## Supplement to the proposal for 04 series of amendments to Regulation No. 10

The text reproduced below was prepared by the experts from France and Germany, to update the list of standards referred in the document, to add new items in the information documents and editorial corrections. Modifications to the existing proposal for amendment of Regulation No. 10: document ECE-TRANS-WP29-GRE-2010-54e., are strikethrough and the new proposals are marked in bold and underlined. Additional justifications are provided at the end of the document.

I.5. Appendix to type-approval communication

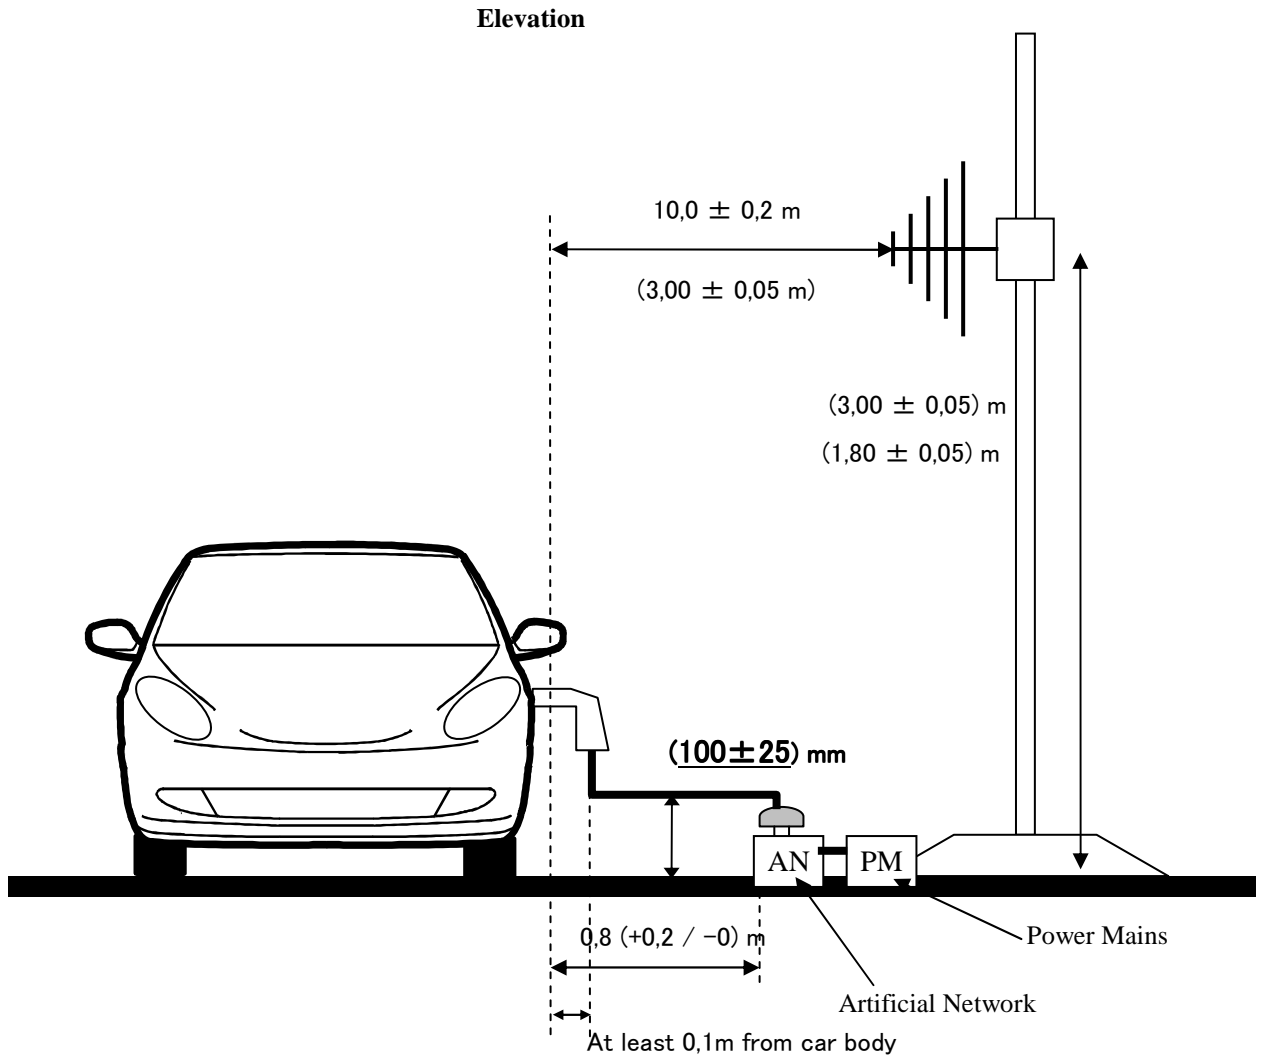
Delete item 2 and renumbered following paragraphs 3 to 6 as 2 to 5

- ~~2. Special devices for the purpose of Annex 4 to this Regulation (if applicable)  
(e.g. ....):~~

### **I.4. Communication Form and I.5. Appendix to type-approval communication:**

To modify the communication form and its appendix, in order to be in line with the EMC directive 2004/104/EC.

**Figure 4**

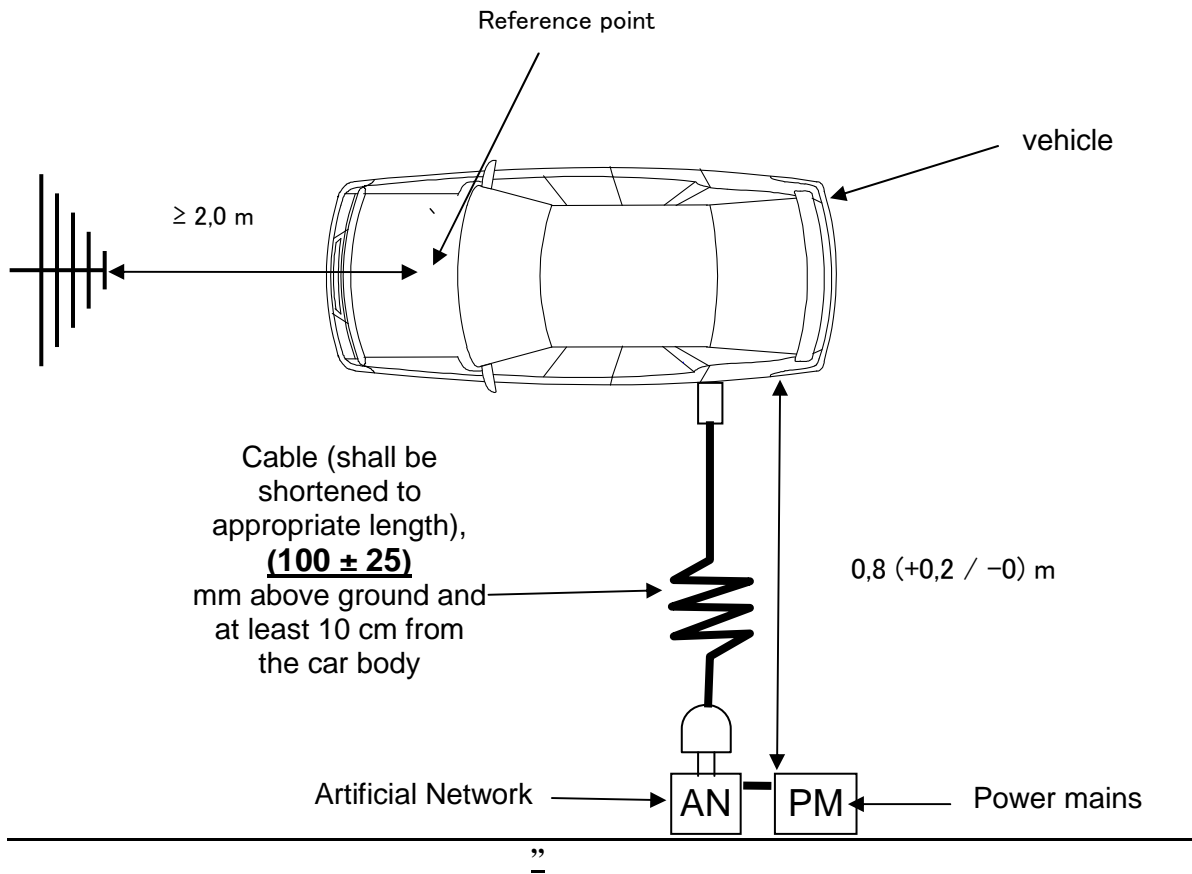
Modify figure 4 in the appendix of annex 6, to read:

**Vehicle in configuration “RESS in charging mode coupled to the power grid”**

**I.6.** For the cable height, we propose to have 100 mm as it is applied in IEC or CISPR specifications. The tolerance +/-25 will cover the cable diameter.
